Towne Square at Suitland Federal Center – Phase 2

SP-230001

MJD-2024-003

STAFF REPORT

Figure 1: Site Plan

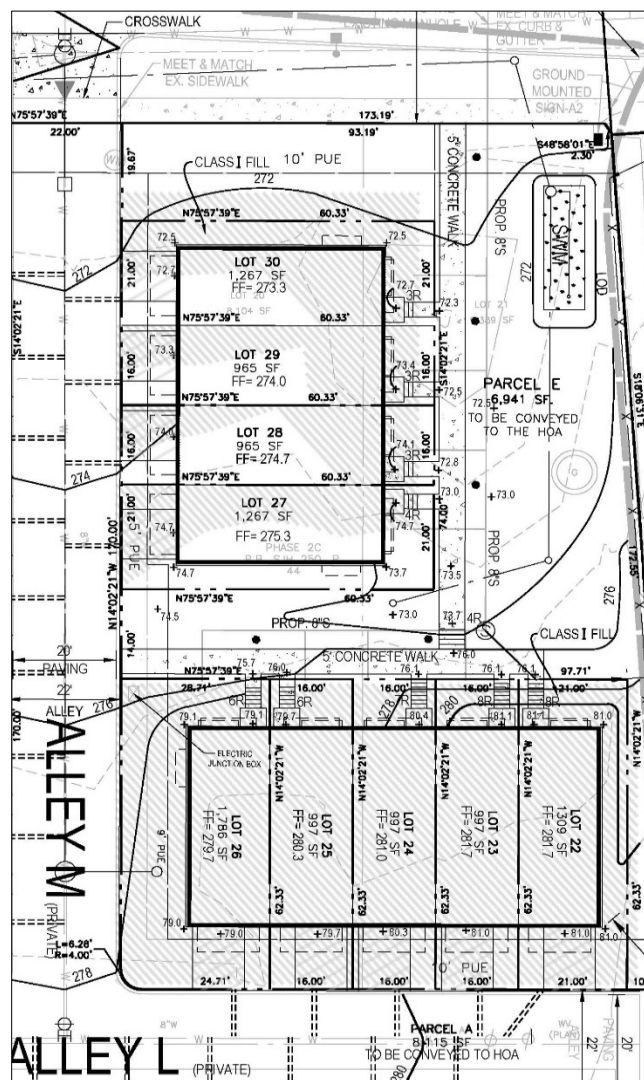
This departure is allowed per Table 27-3614(b)(2): Major Departures of the zoning ordinance. A departure is required to have townhouse Lots 27-30 front an inner courtyard rather than Towne Park Road. The courtyard will be landscaped with trees, shrubs, a bioretention swale, and a fence along the property line. The subject site is situated within the overall Towne Square at Suitland Federal Center development. As stated in the applicant's SOJ, the proposed layout and architecture of the townhouses is designed to blend into the rest of the development, which was approved in SP-150004. Having the townhouses face an inner courtyard, rather than the street, will still provide future residents with access to Towne Park Road. The

Comments were provided to the applicant following the Subdivision Development Review Committee meeting, held on April 05, 2024. One comment provided stated that the location of the subject development is unique as it is across from, and adjacent to single-family detached residences. To better interact with the public realm on Towne Park Road and maintain a transition area to the nearby single-family residences, staff requested the architecture for Lot 30 be redesigned to have the side elevation mimic a front façade. This could be accomplished by incorporating a front door, portico, front porch/stoop, and/or other architectural elements that typically characterize the front of homes. In addition, staff conducted a site visit with the applicant's team on May 08, 2024.

This departure is allowed per Table 27-3614(b)(2): Major Departures of the zoning ordinance. A 5-foot-wide sidewalk is proposed along the street frontage. The applicant states in their SOJ that the overall Towne Square at Suitland Federal

The applicant has updated the SP plan to include a 5-foot-wide sidewalk along Towne Park Road and a striped crosswalk at the intersection of Alley M and Towne Park Road.

- 1. Prior to certification of the special permit, the applicant and the applicant's heirs, successors, and/or assignees shall provide the following:
 - a. Revise the side/north elevation of the unit closest to Towne Park Road, Lot 30, to include additional design features such as a two-story bay window, a minimum of two windows on the ground floor, and a minimum of five windows facing Towne Park Road, or other such features as agreed upon by the applicant and approved by

- b. Revise Stormwater Management (SWM) Concept Plan 21525-2015-04 to match the proposed layout to include nine townhouse lots.
